MEETING: REGULAR MEETING OF THE PLAN COMMISSION

DATE & TIME: Monday, February 12, 2024 at 6:30 PM

- B. American Architectural Group, Agent for Washington Drive LLC, Property Owner, and Midwest Products, Inc.- W129 N11025 Washington Drive. Site Plan Review for a new 52,038 sqft manufacturing and warehouse building - Revised Building Elevations. (ACTION)

- C. Excel Engineering, Inc., Agent for Bethlehem Lutheran Church, Property Owner N100 W14290 Bel Aire Lane. Site Plan Review for a 23,471 sqft Building and Parking Expansion-Revised Site and Landscaping Plans. (ACTION)

WEST ELEVATION

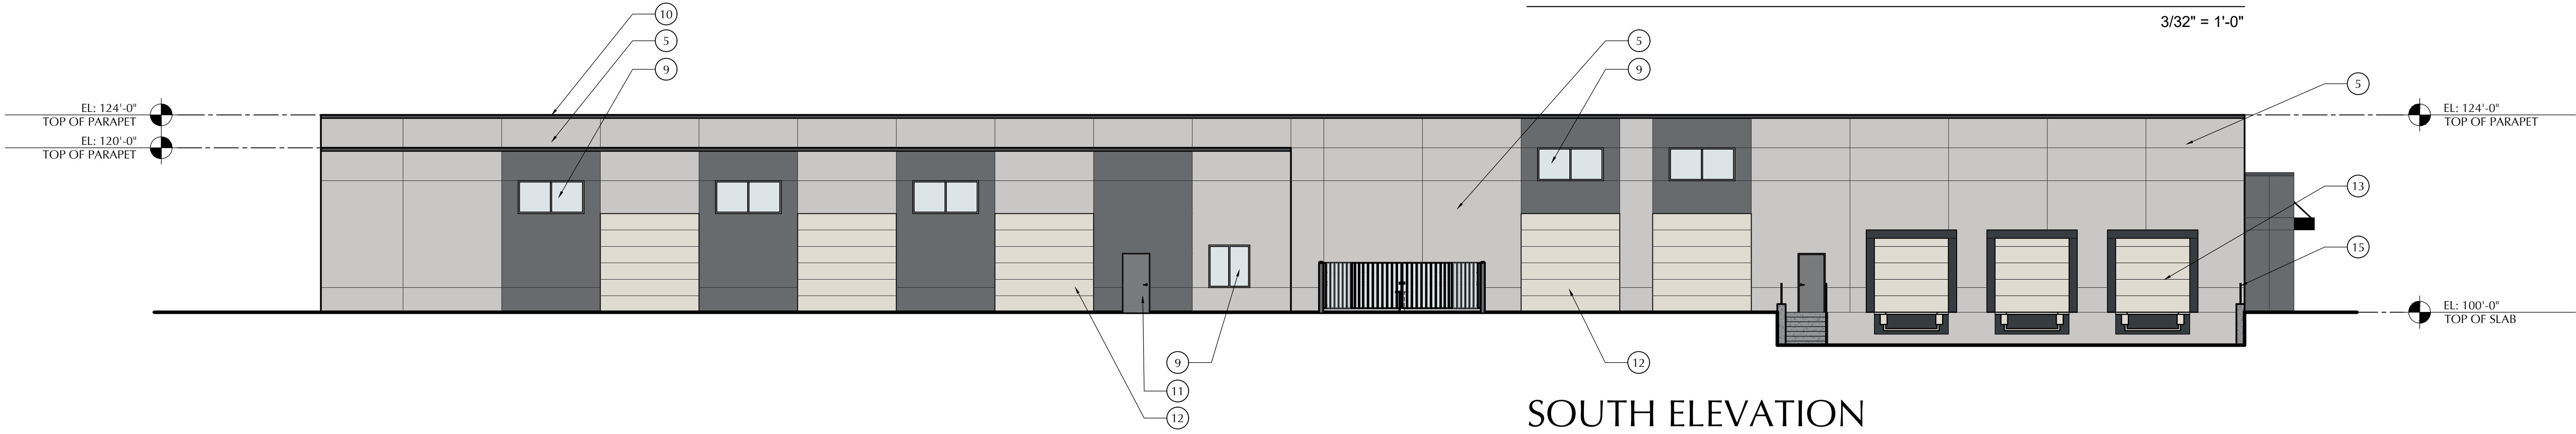
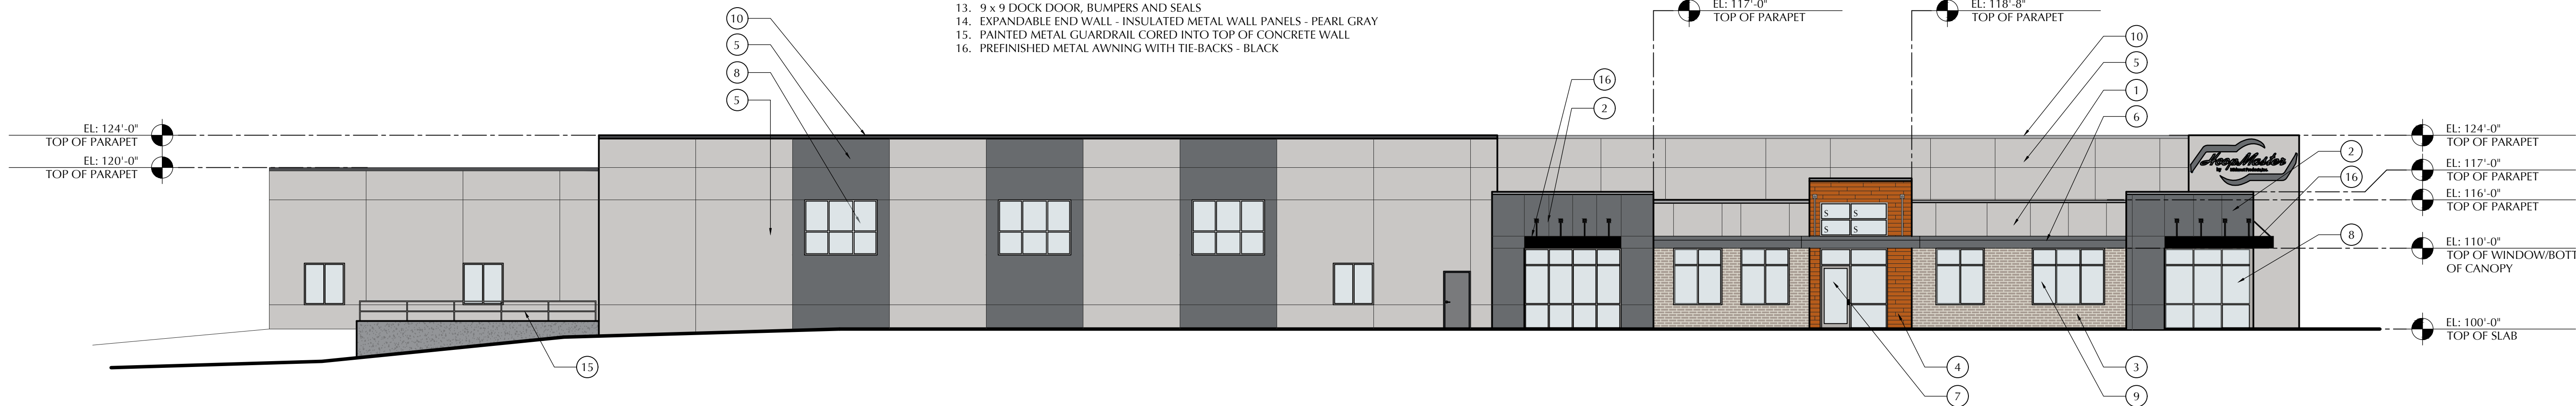
11. The building architecture has insufficient articulation and/or other architectural and material features necessary to meet the architectural requirements in the Germantown Business Park covenants. Additional reveals, articulation, materials and/or textures should be included in the design. Revised elevation plans shall be prepared and submitted for review and approval by the Plan Commission prior to issuance of a building permit (serving as the Architectural Review Board for the Village and Germantown Business Park).

said his motion is to reject the 2-dimensional elevations in favor of the 3-D rendering. New elevations should be submitted for the west and south with the new color scheme based on the rendering. Discussion continued on the south elevation. Trustee Baum questioned if the 5 windows shown on the south elevation will be dark gray and the dark gray removed from the top. Mr. Hertel explained the windows are a different type and the intention was to make the south elevation light gray. Trustee Baum said he would have a problem with that and wants to see more interest. He said the west elevation is for future expansion and he could accept that wall being left a little plain except the dark gray cap. The new elevations should match the renderings and also address the area where the sign panel will be removed.

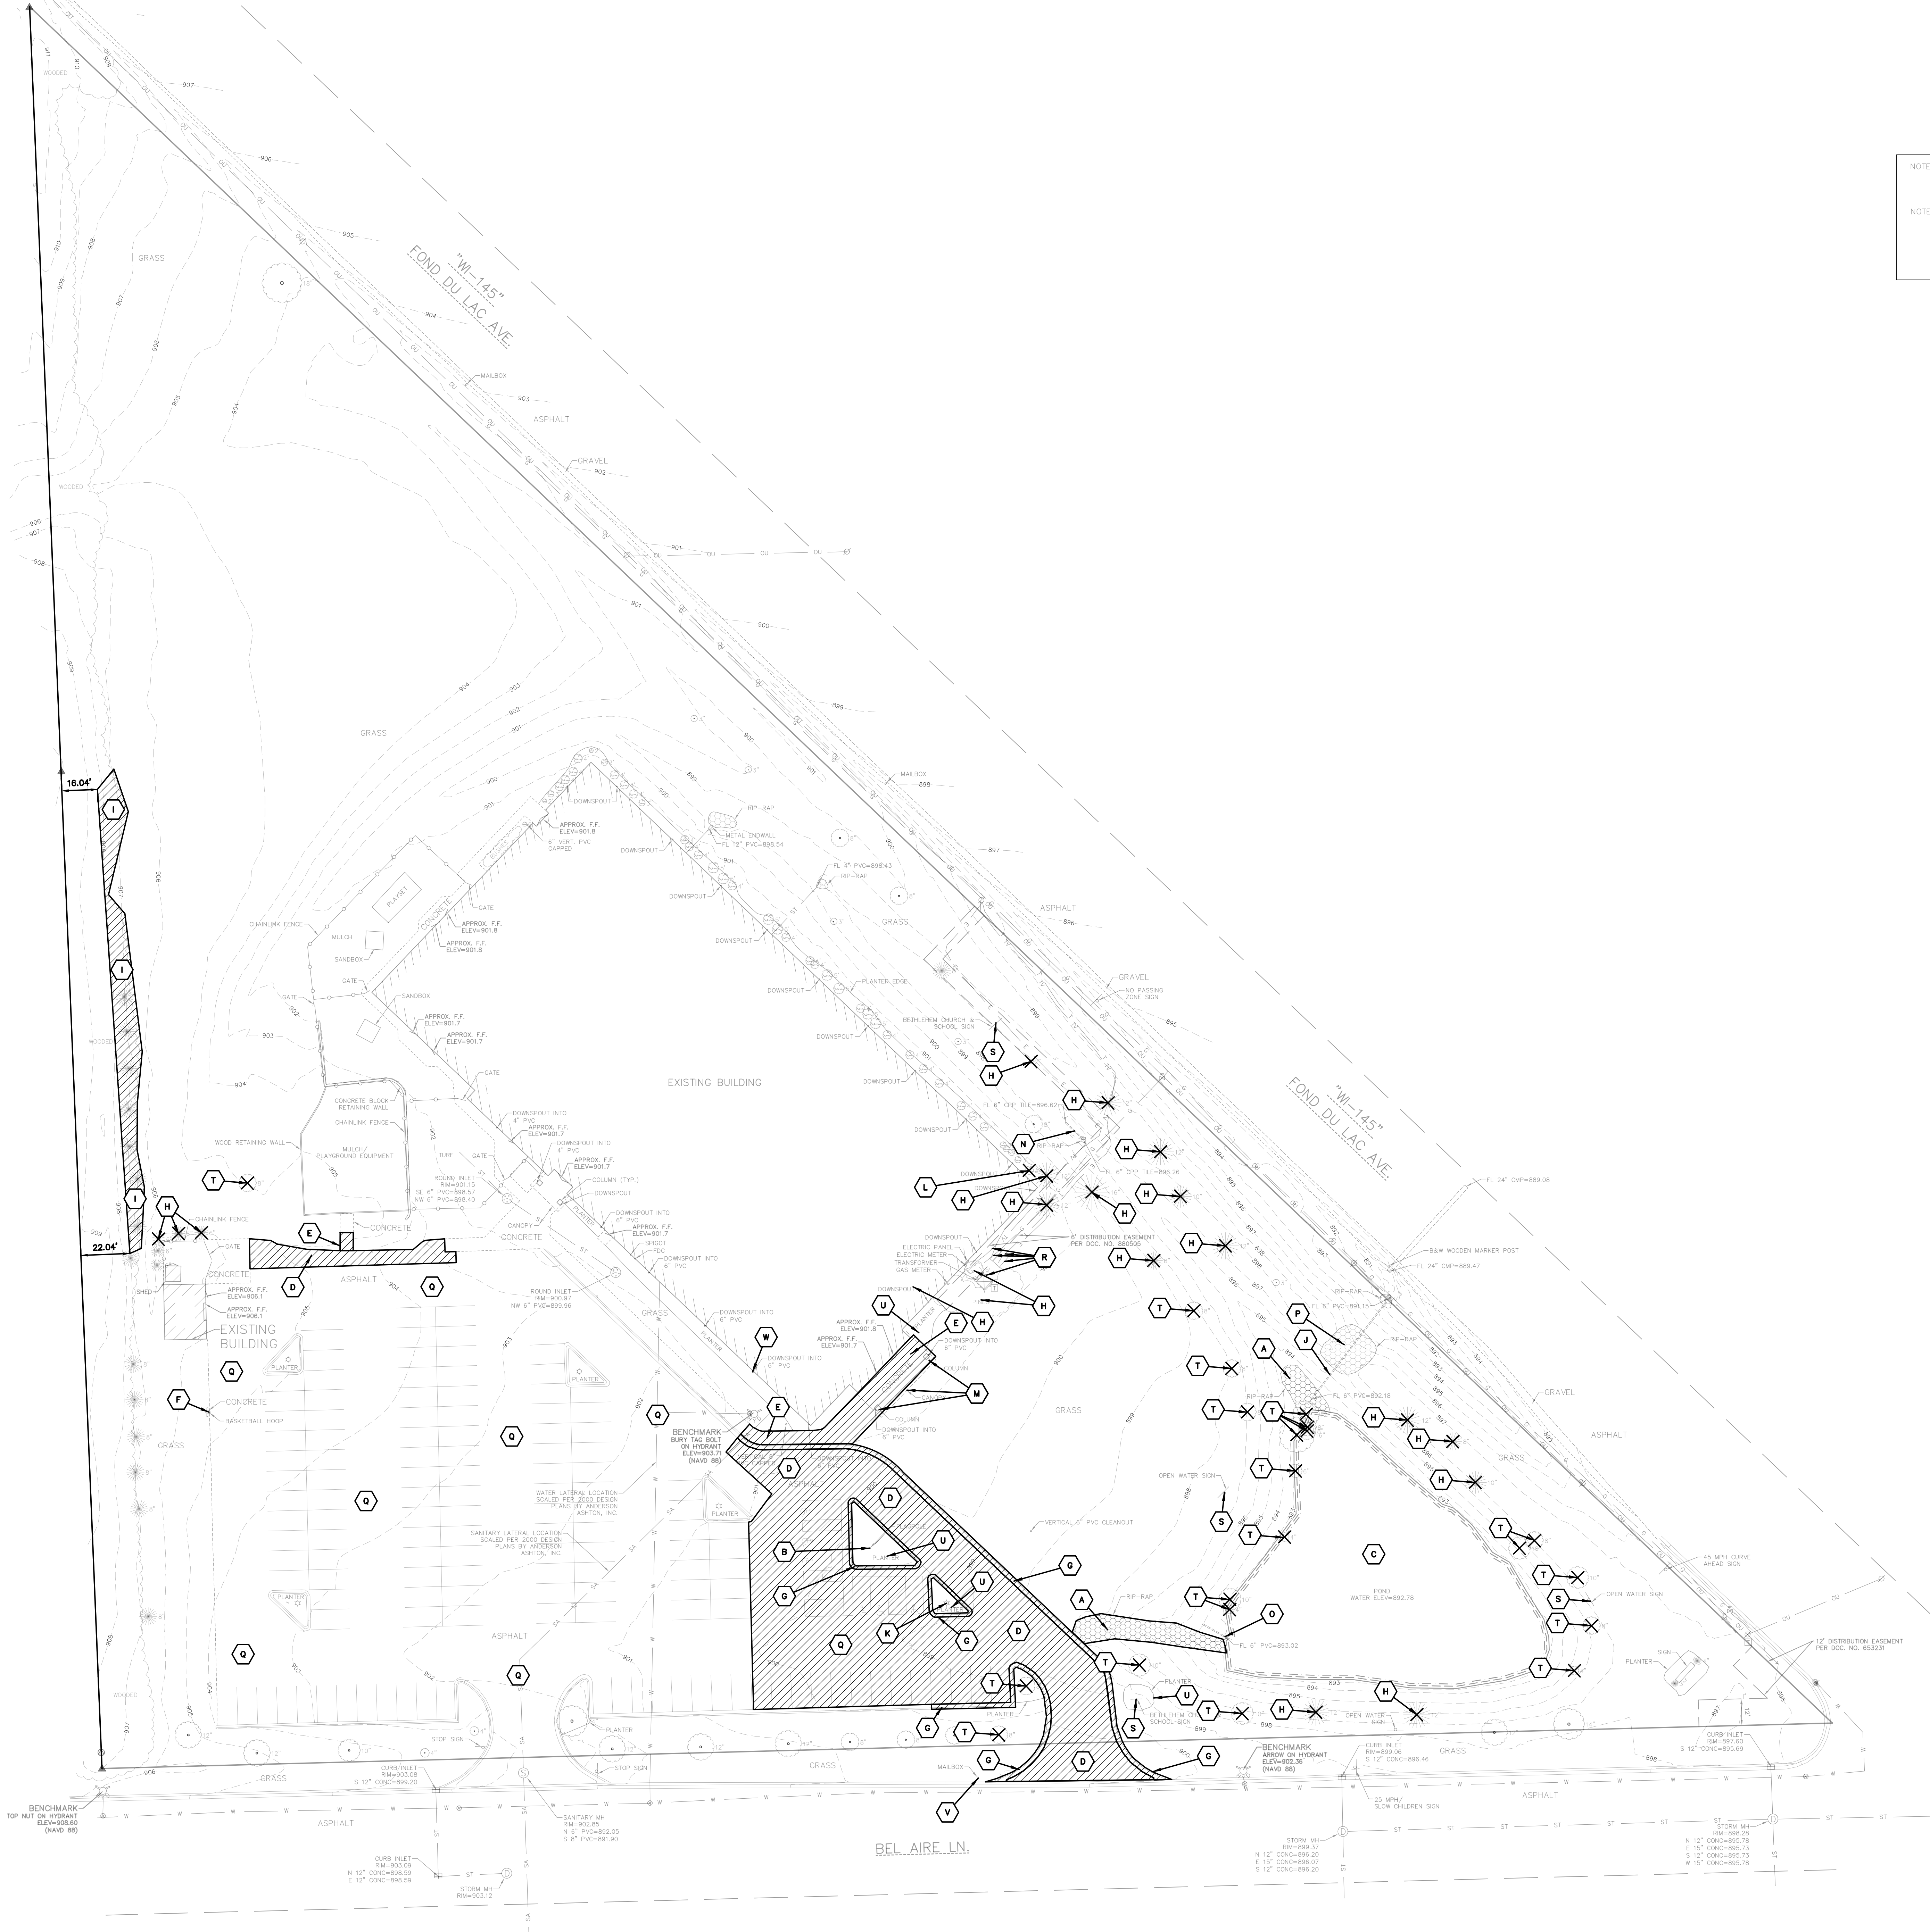
2. Sheet C1.0 (Demolition Plan) indicates that all of the existing trees along the west property line in the vicinity of the new parking lot will be removed (it doesn't say "all" but doesn't any trees will be preserved either). The grading plan indicates that the limit of disturbance is right up to the west property line that appears to run right through the middle of the tree line. This is very concerning. Section 17.45(1)(b) indicates that berming with landscaping may be required by the Plan Commission in situations where parking lots abut residential districts. The existing tree line is quite substantial with mature (>15' height and >10'-15' spread) deciduous and evergreen trees placed in such a way that there is an existing visual screen between the residential lots and the proposed parking lot... a lot that also introduces exterior lighting into the area where previously there was none. Somewhat surprising is that the proposal is to install only four (4) 6' high evergreen trees. This is inadequate even with some of the trees that

CIVIL SITE PLAN

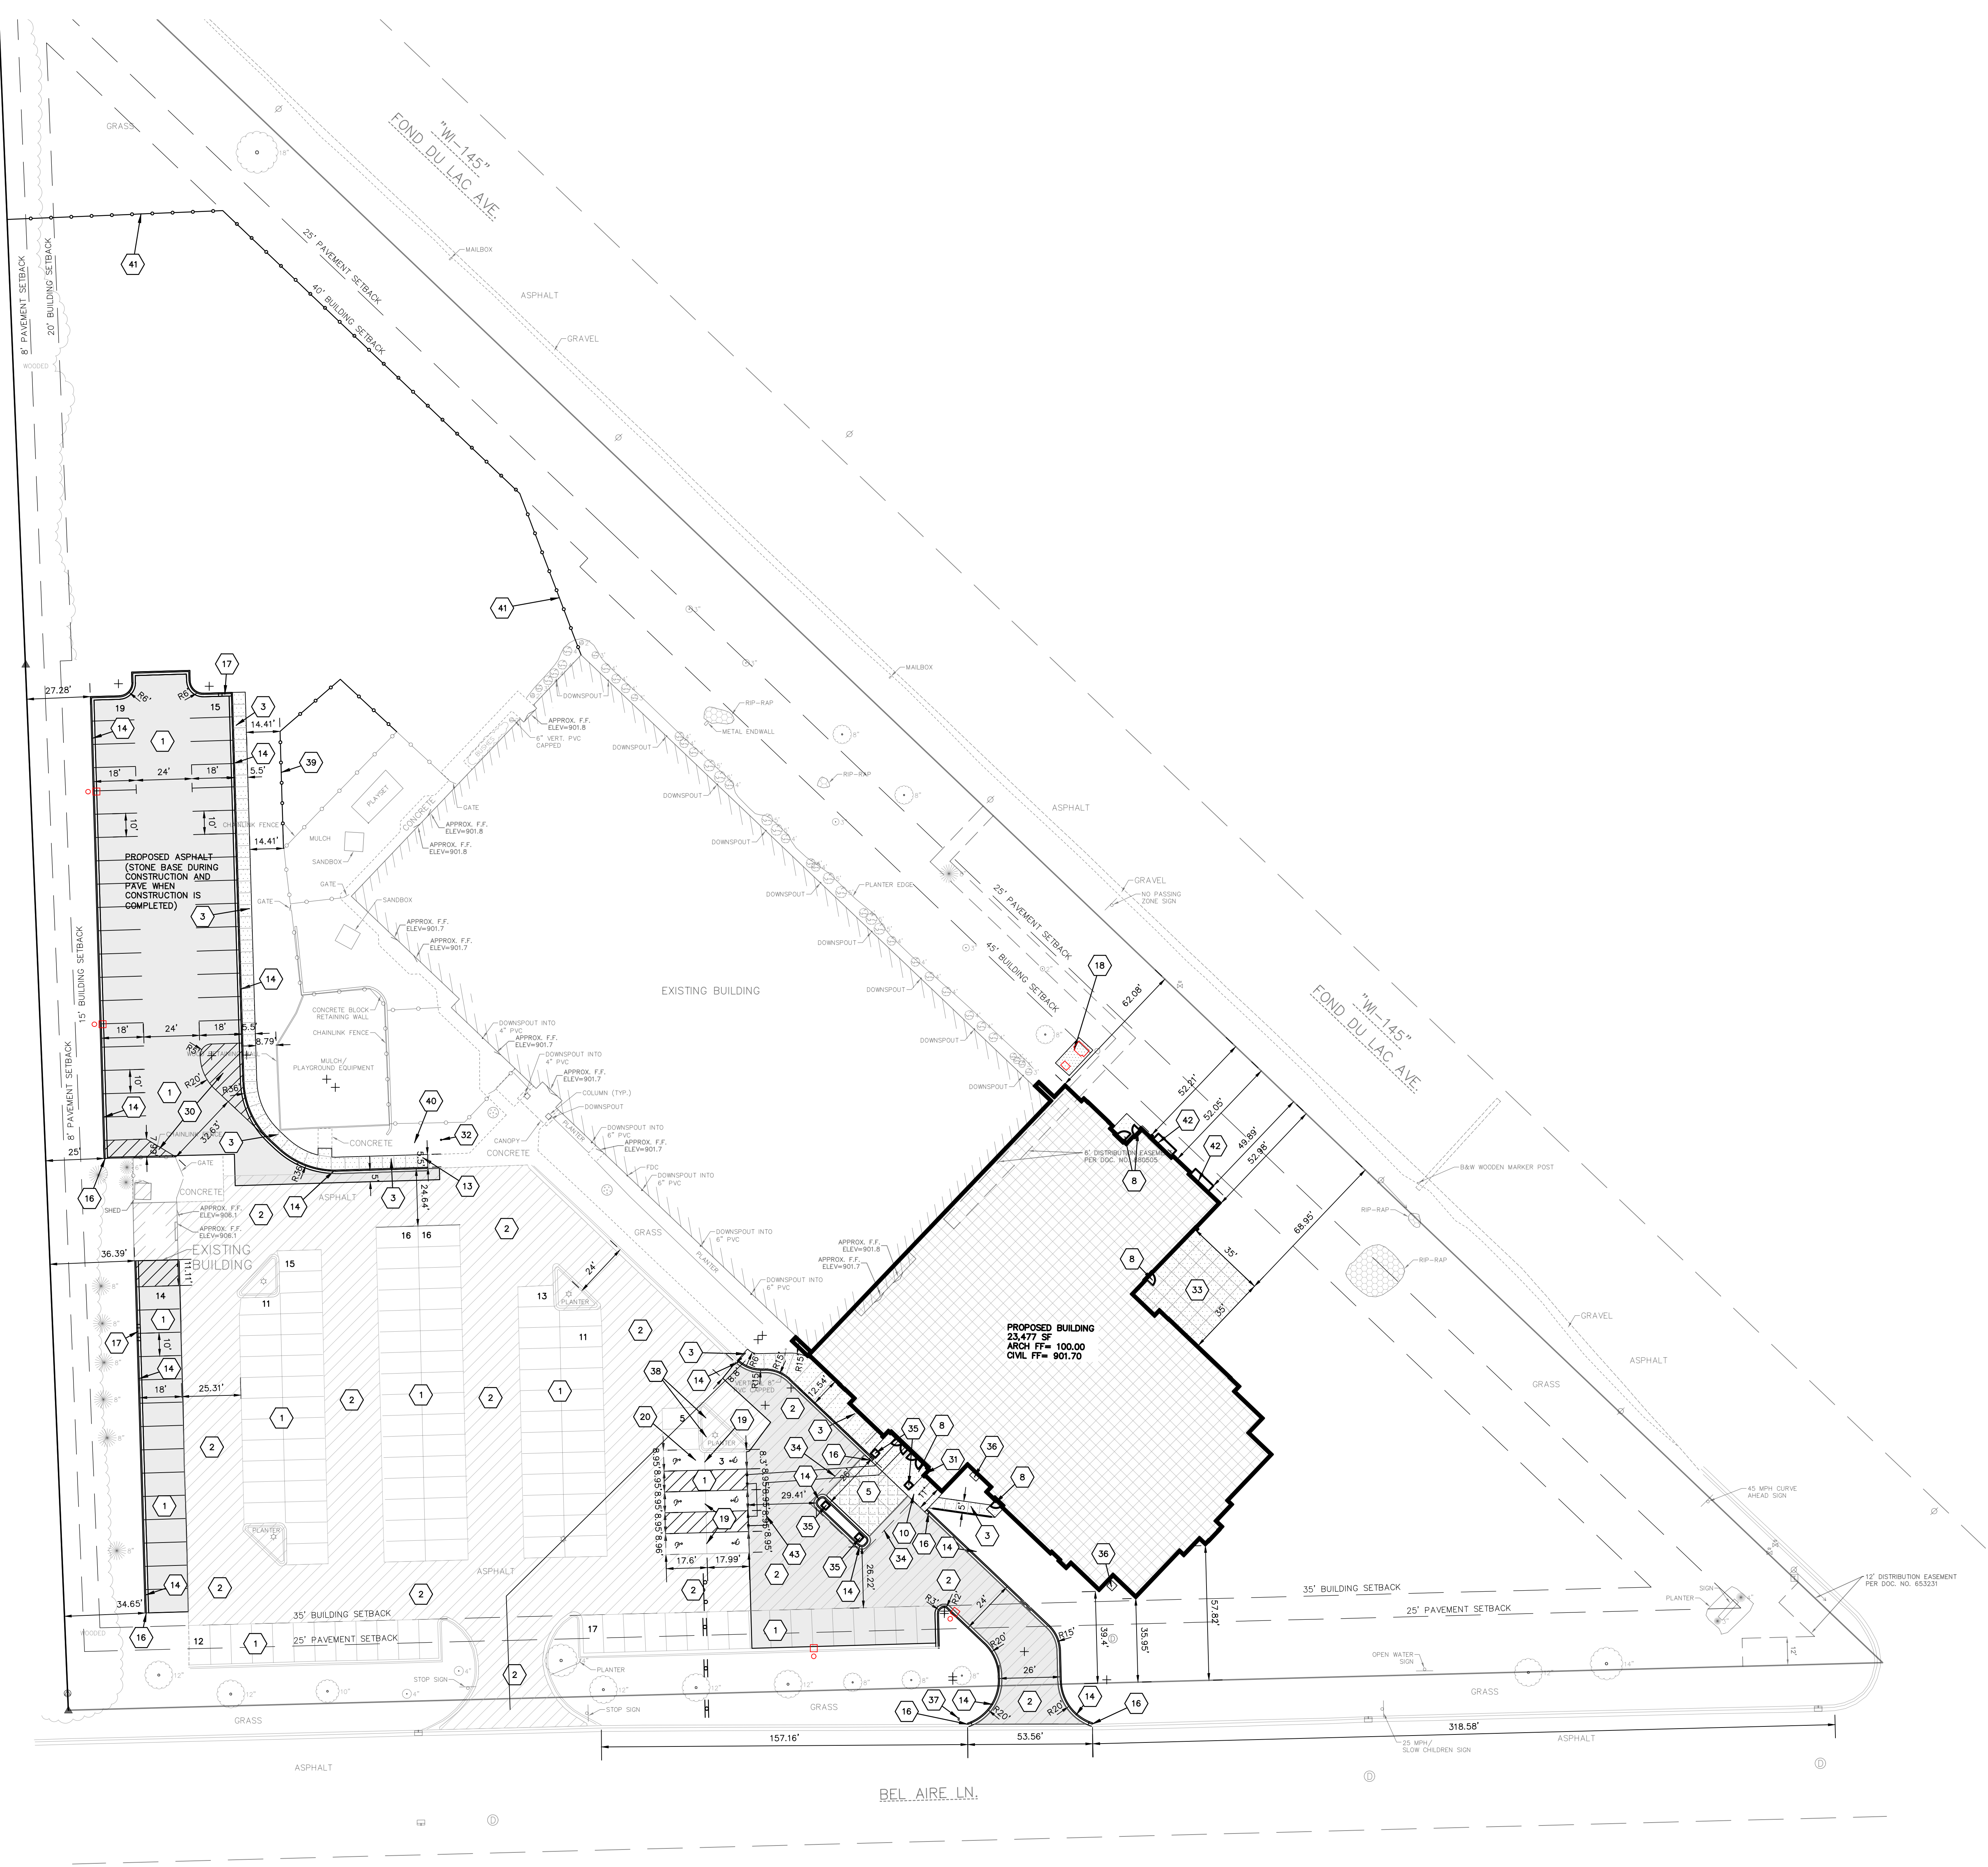
6. The proposed parking lot along the west property line shall be moved to meet the minimum 20' setback requirement. Sheet C1.1 of the plan set indicates that the southwest corner of the new parking area along the west property line is setback 19.41 feet (and tapers to a setback >20 feet somewhere along the edge as it moves northerly).

1. Section 17.45(1)(b) of the Zoning Code requires parking lots for churches to be setback a minimum of 20 feet from the property line if an adjoining property is in a residential zoning district. In this case, the land to the west of the church property is zoned Rs-4. Sheet C1.1 of the plan set indicates that the southwest corner of the new parking area along the west property line is setback 19.41 feet (and tapers to a setback >20 feet somewhere along the edge as it moves northerly). The plan will need to be revised to meet the 20' setback.

With respect to the west property line and existing tree line, the proposed parking lot has been shifted approximately five (5) feet to the east and further away from the property line (to a setback of 25'-27' from the property line to the curb (see Sheet C1.4). In so doing, the limits of disturbance have also shifted from right at the property line to a point at least 16' to the east. As a result, at least 16' of the existing vegetation will remain untouched (although invasive/scrub brush will be removed). Further, a total of fifteen (15) deciduous and evergreen trees are proposed along the western edge of the new parking lot to replace the trees being removed and enhance the remaining buffer along the property line.
